Development Review Division

SUBJECT: SUB20-002, Douglas 234 Filing 6 – Minor Development Plat Review Comments v2

A REPLAT OF LOT 1, BLOCK 10, DOUGLAS 234 FILING NO. 1, BEING LOCATED IN SOUTHEAST QUARTER OF SECTION 29, TOWNSHIP 6 SOUTH, RANGE 66 WEST 6TH P.M. TOWN OF PARKER, COUNTY OF DOUGLAS, STATE OF COLORADO SHEET 1 OF 2

LANDSCAPE AND IRRIGATION PLANS
DOUGLAS COUNTY 234
FILING NO. 6
DOUGLAS COUNTY, COLORADO

TREE
MITIGATION PLAN

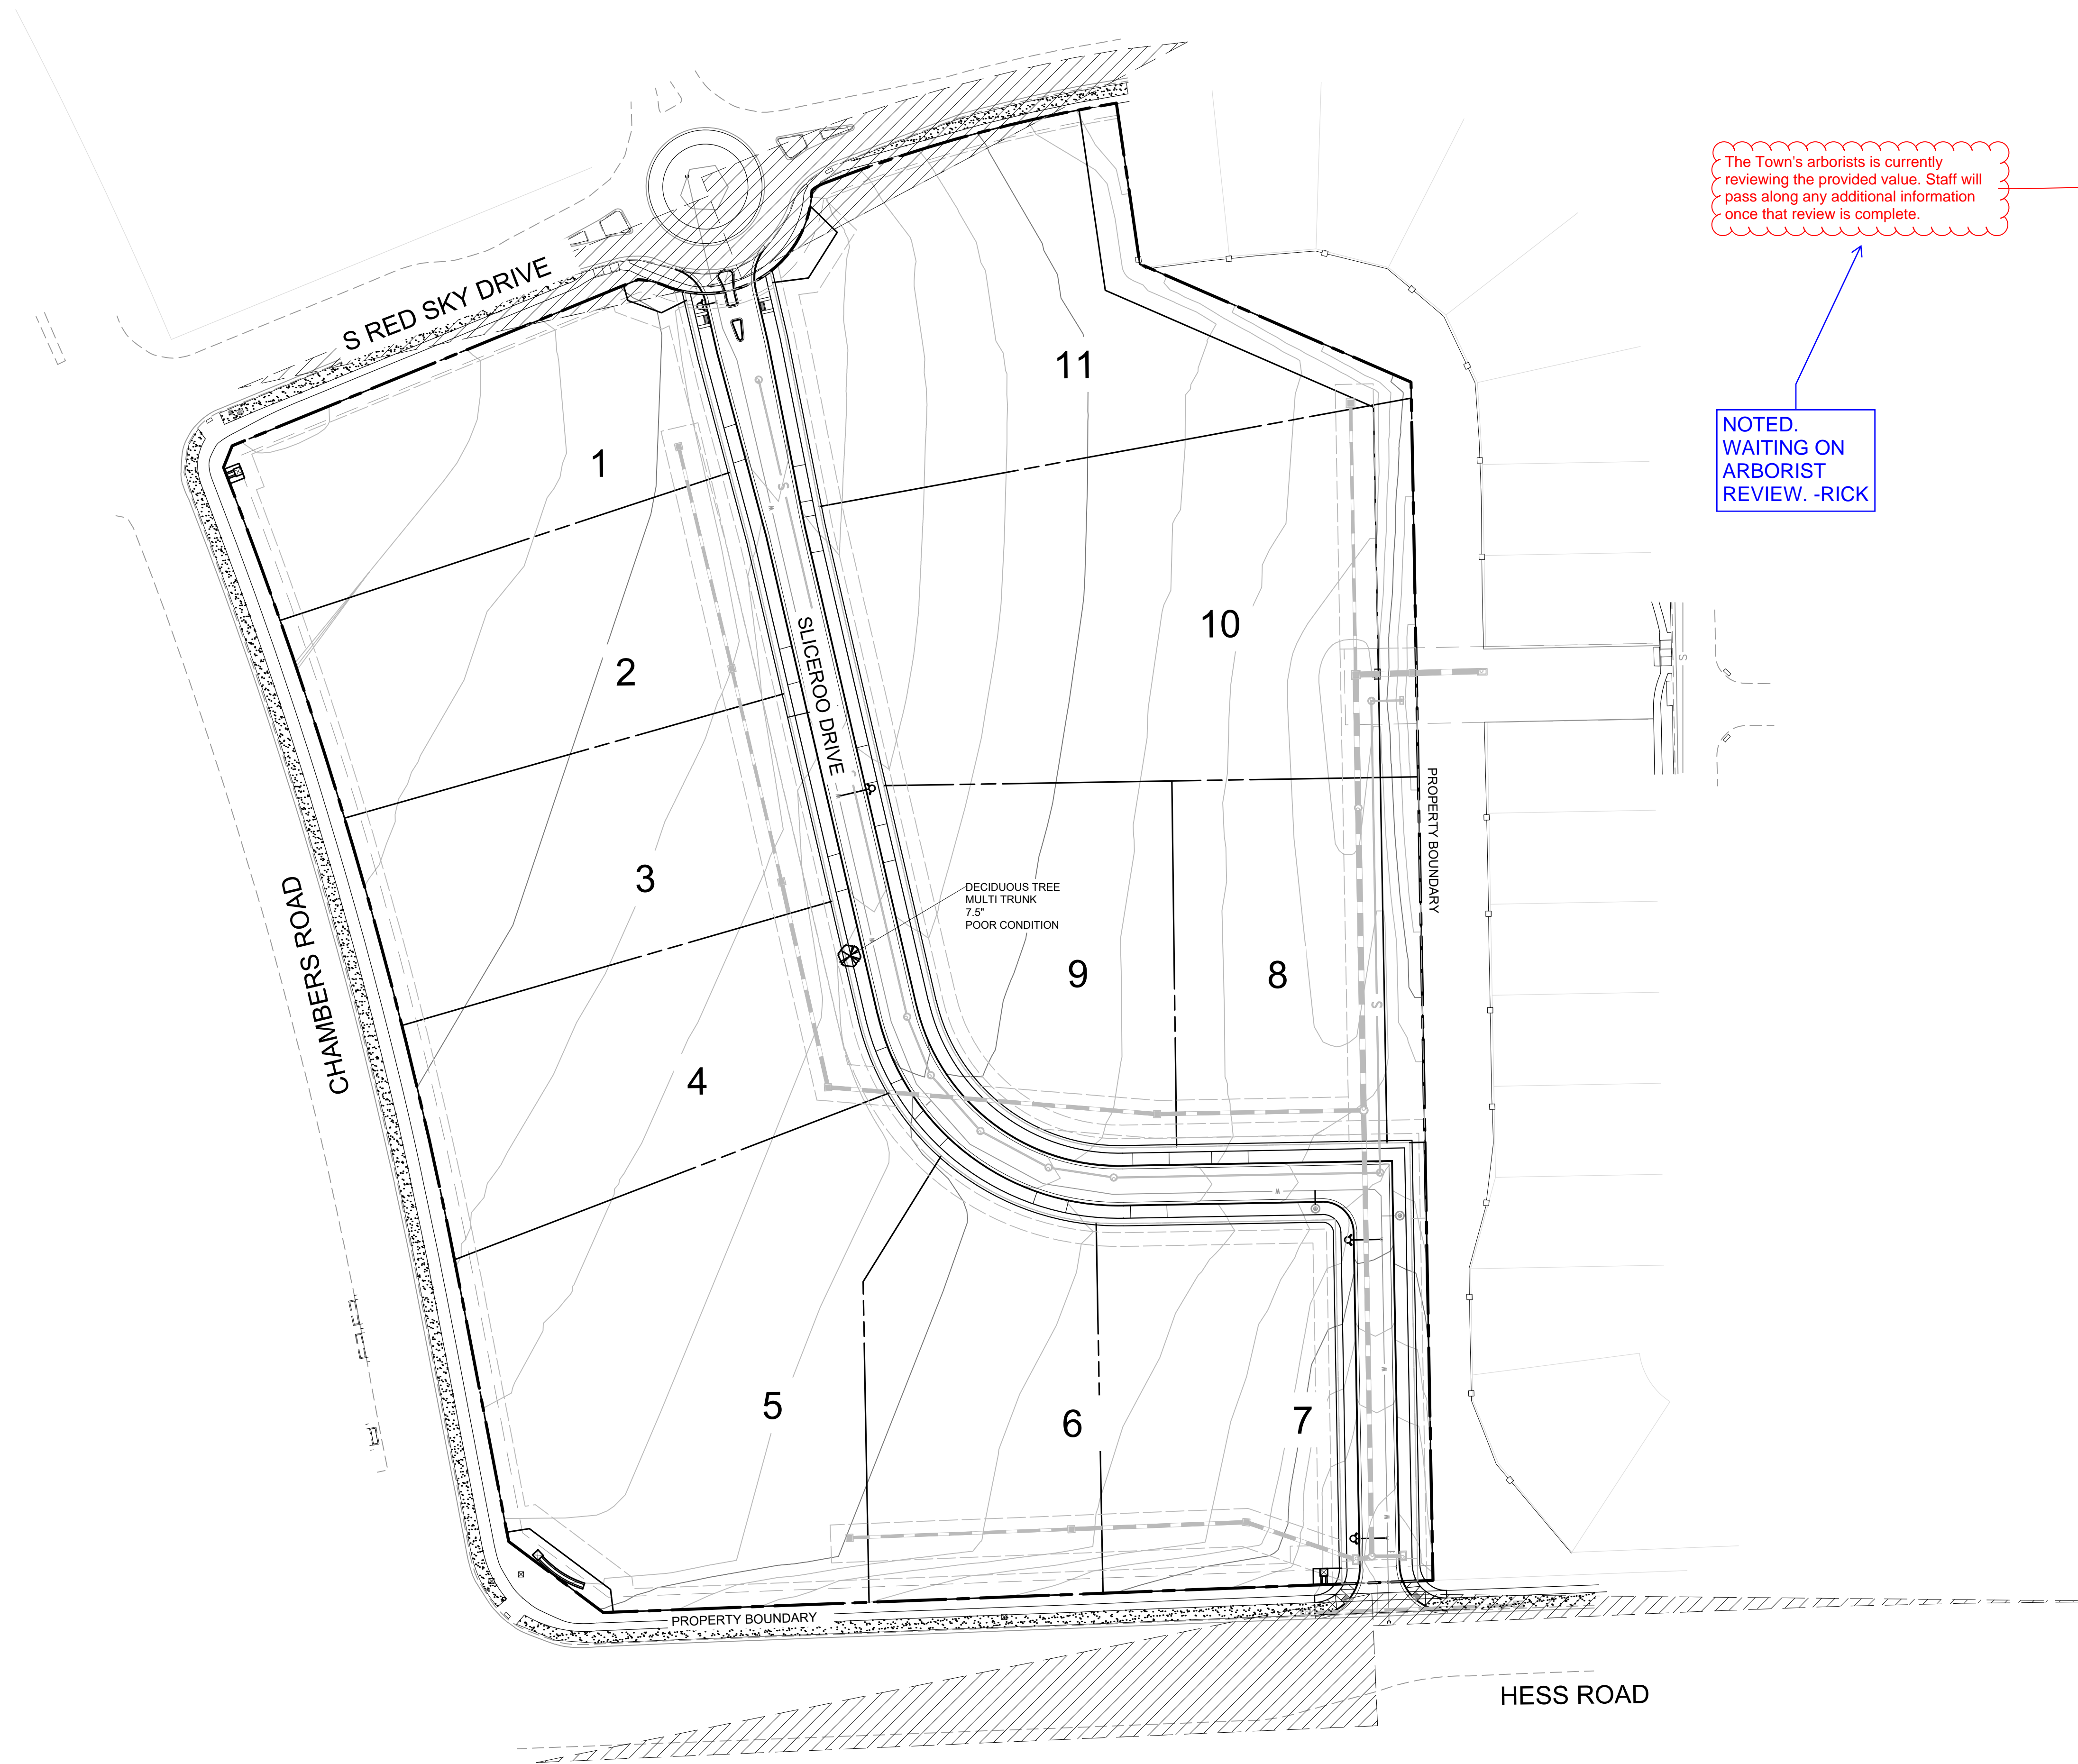
The Town's arborists is currently reviewing the provided value. Staff will pass along any additional information once that review is complete.

NOTED.
WAITING ON
ARBORIST
REVIEW. -RICK

LANDSCAPE PLAN

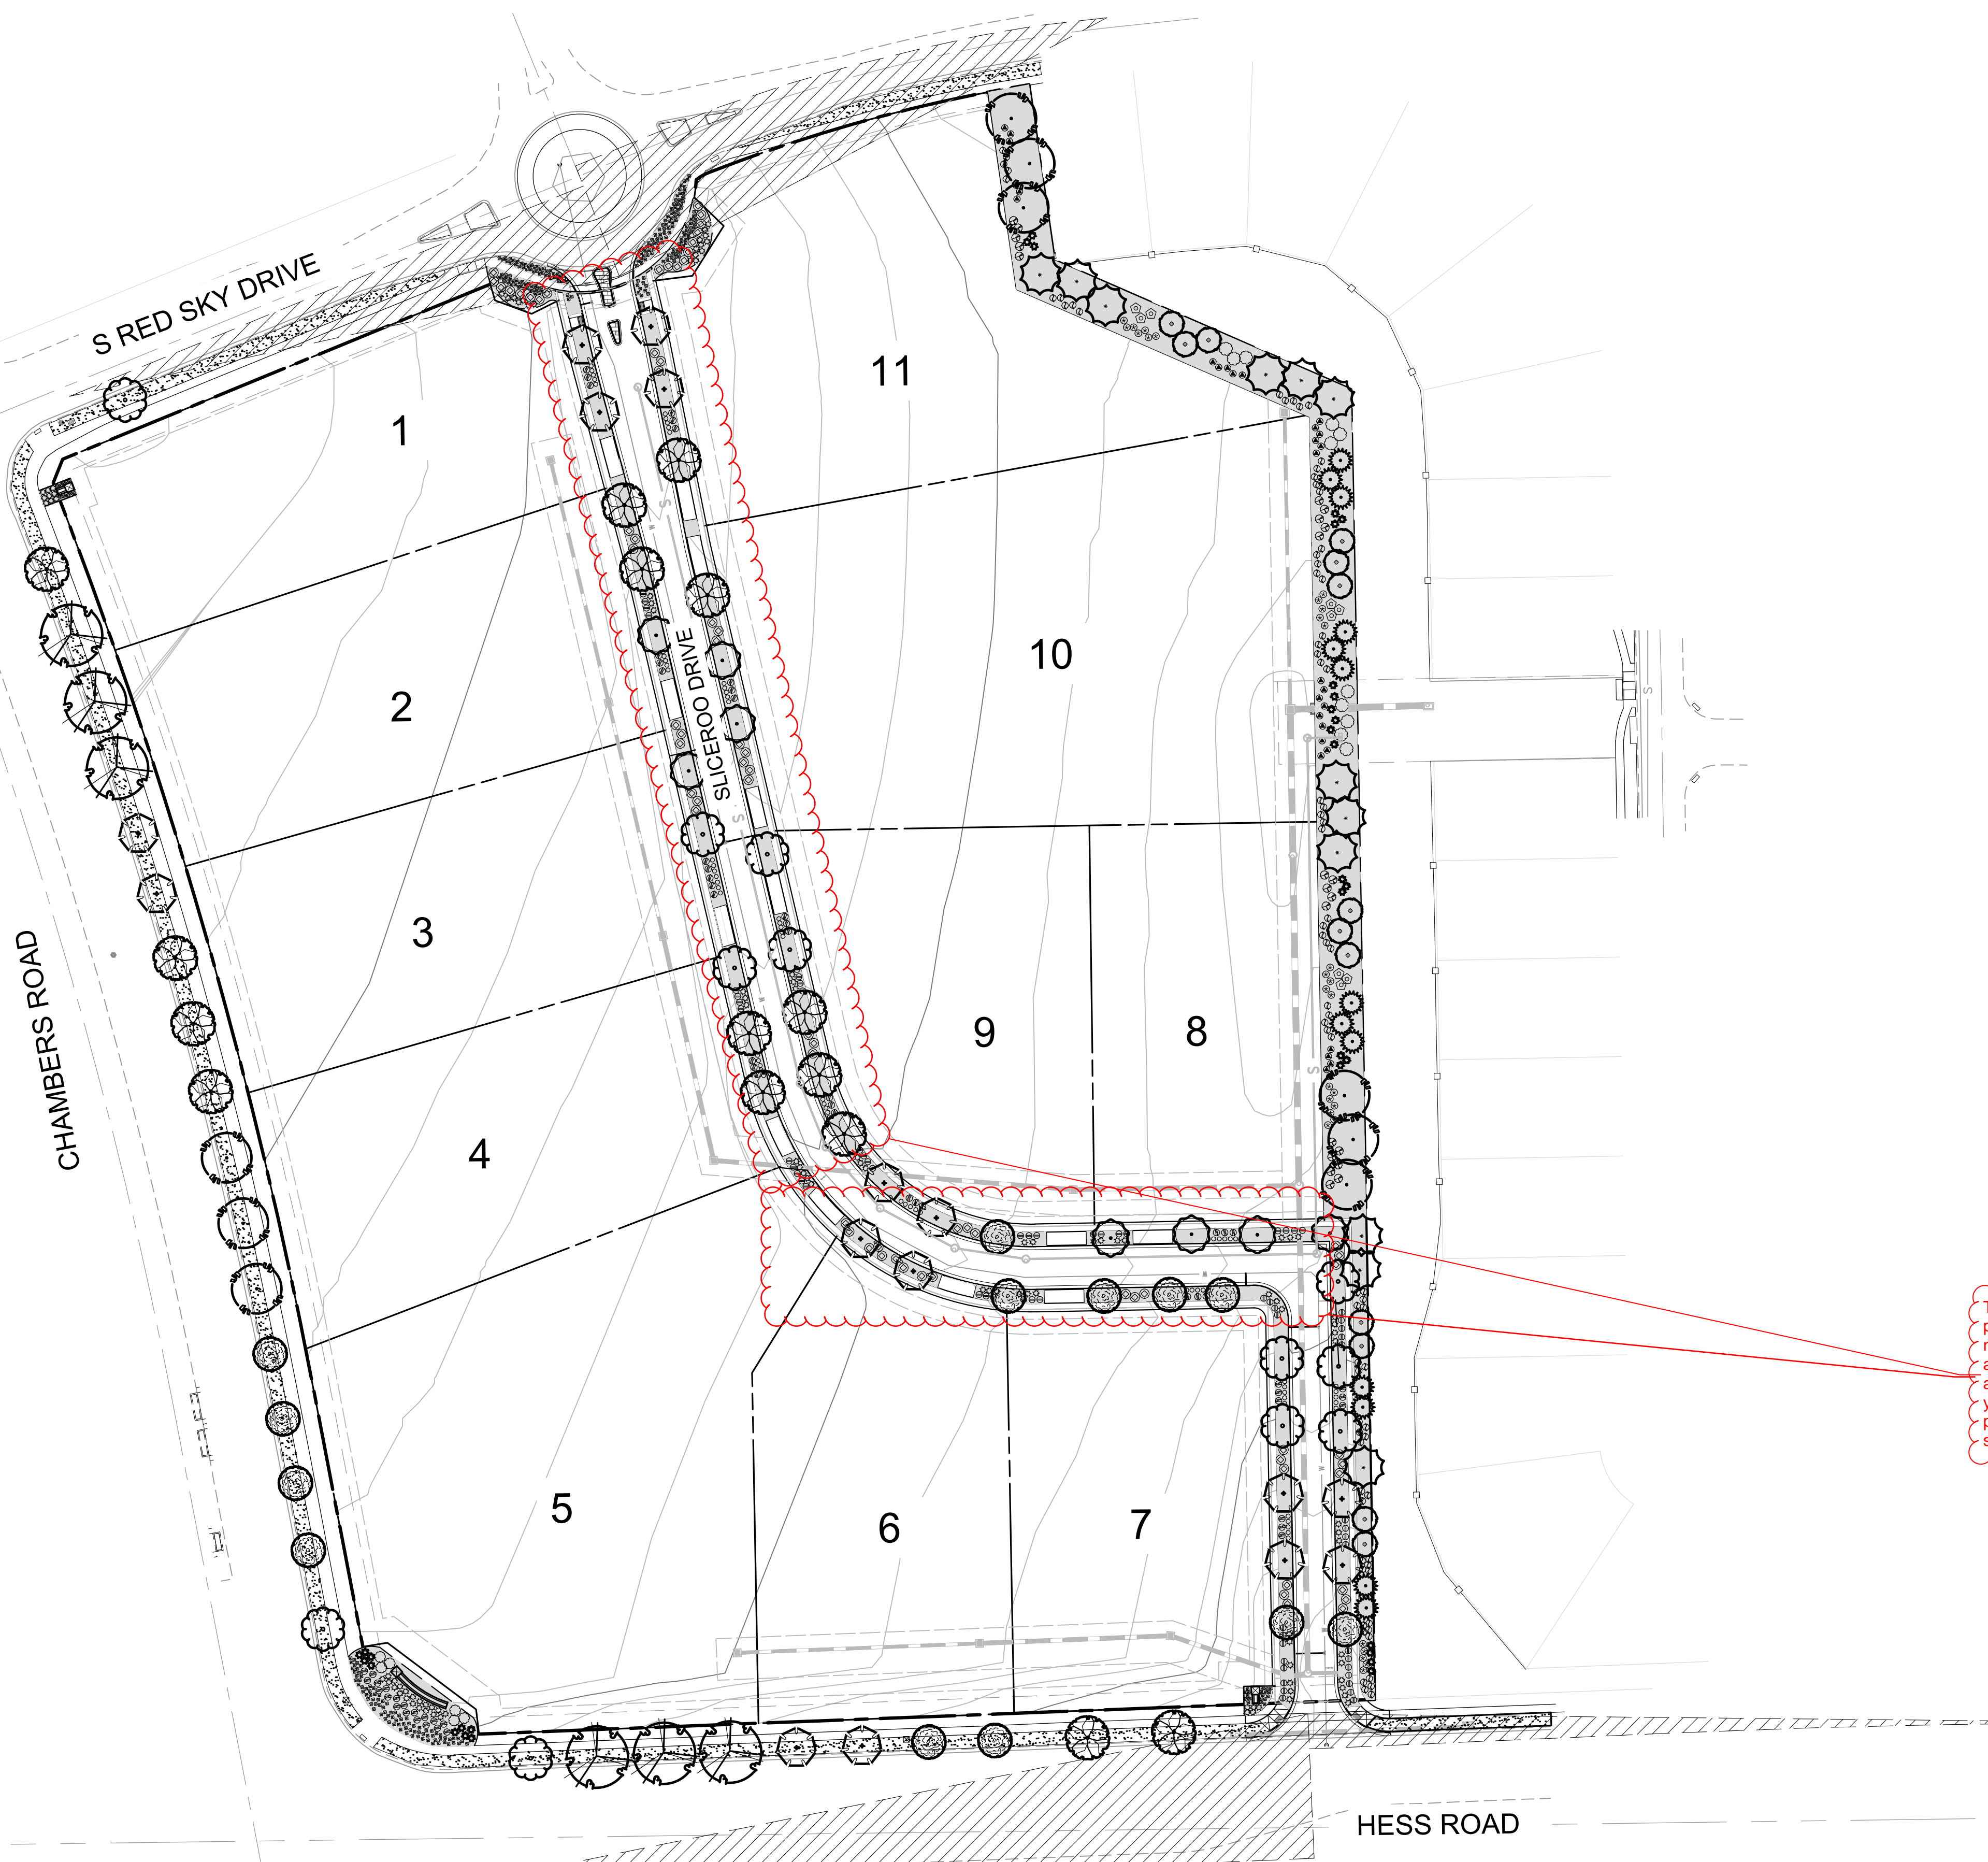
The Town encourages shared access points. The proposed landscaping does not provide the opportunity for shared access points. Access points should also align to those across the street. If you have questions on where access points should be based on the Town's standards please let staff know.

ACCESS POINTS HAVE BEEN RELOCATED AND ADDITIONAL NOTES ADDED.-RICK

LANDSCAPE NOTES & DETAILS

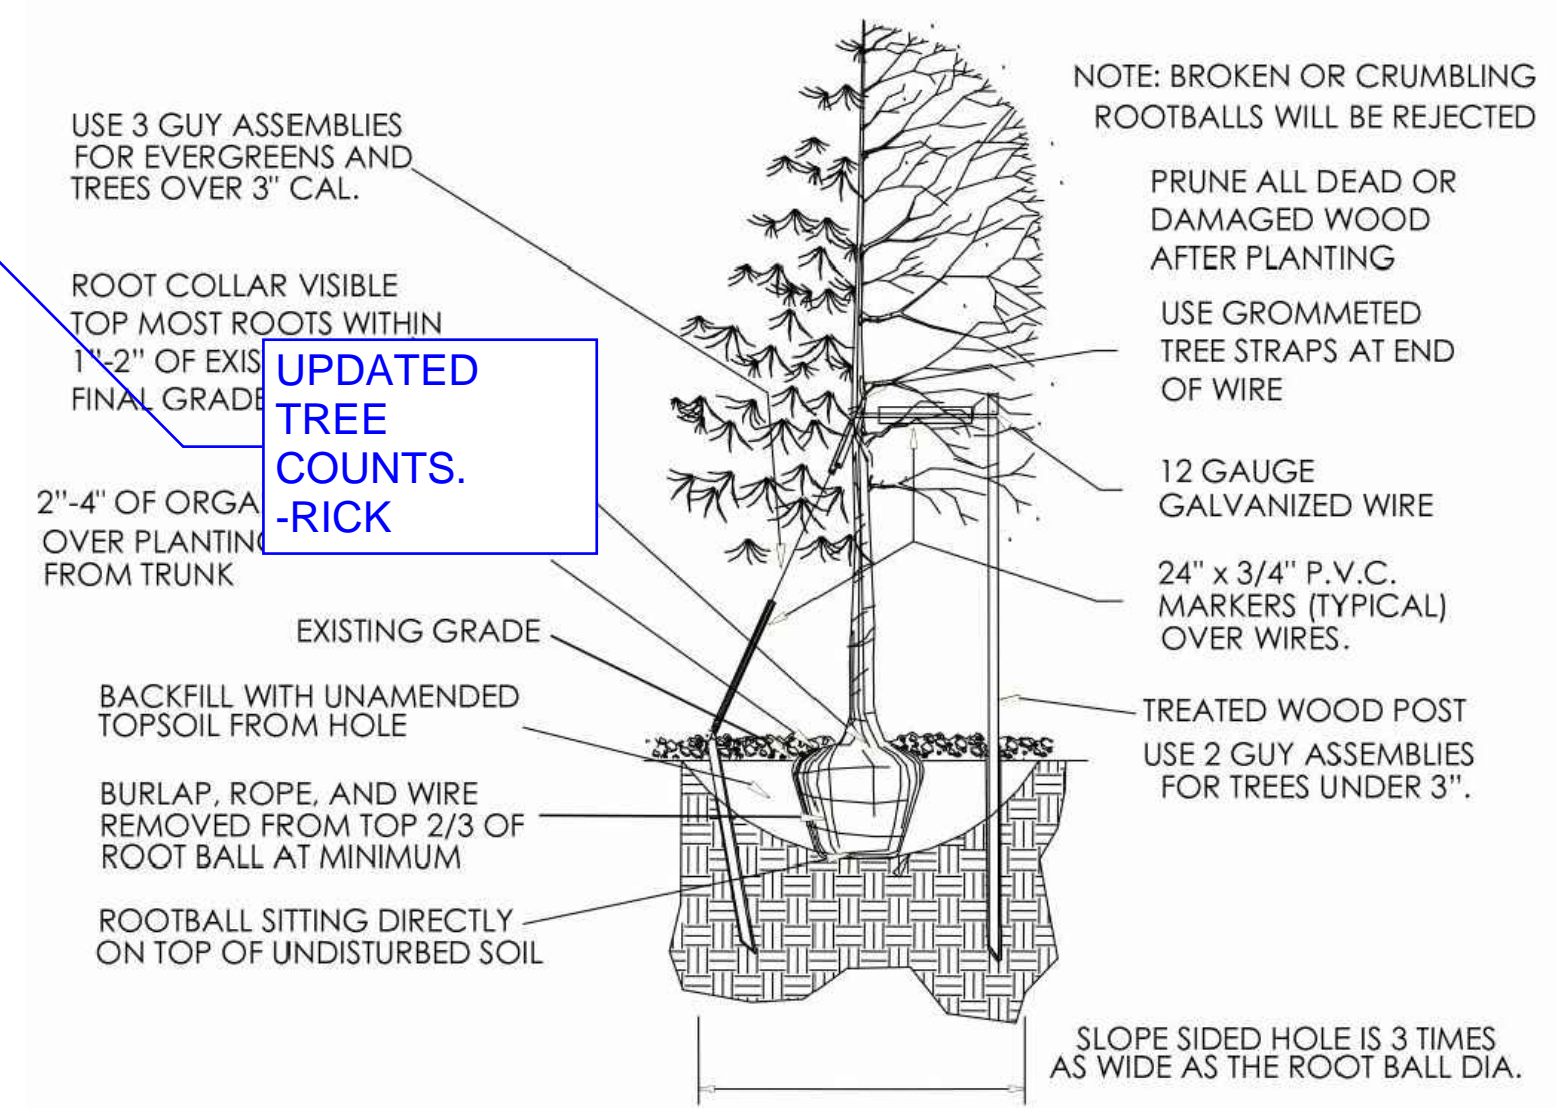
The Town is not able to waive any landscape standards. The required number of street trees must be met. Please adjust accordingly.

Per Section 13.06.070(g) Schedule 13.06.070B All fractional requirements shall be rounded up. Please adjust accordingly.

UPDATED SHRUB COUNTS. -RICK

UPDATED TREE COUNTS. -RICK
